## RE: H&G adjustments to accommodate fencing solutions

### Option 5 – Boundary Fence either 1.8m or 2.4m with Perspex Panelling on the rear of the Racking

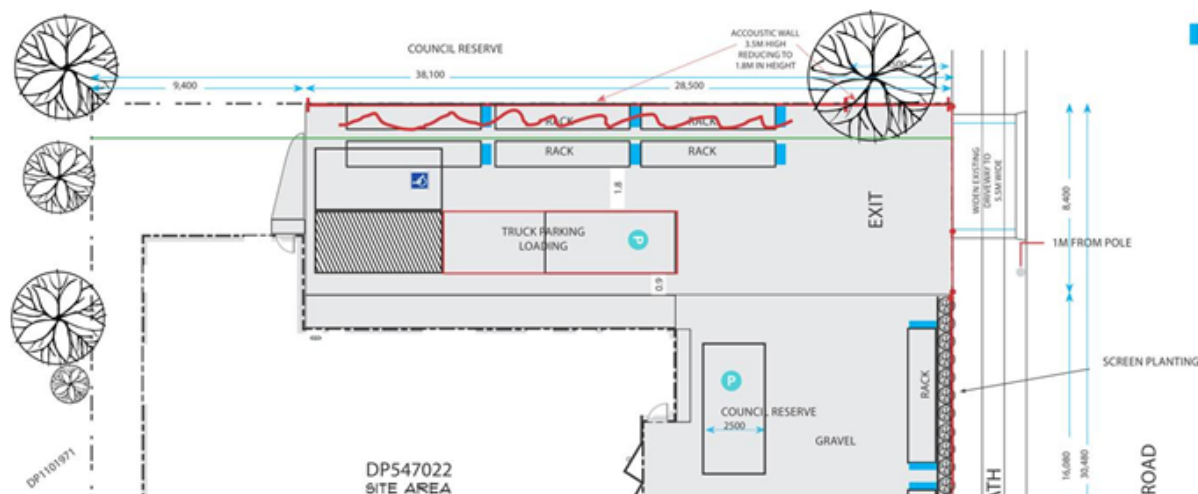
- Fence location along the boundary line of the property.
- Fence along the boundary can either be 1.8m high or 2.4m high
- On the rear of the racking, the a solid Perspex backing is installed to a height of 3.3m as shown in the drawing below.
- No changes to the management controls (number vehicles and their locations etc.).
- Compliance is achieved at the neighbouring property (i.e. 61-63 Myoora Road).
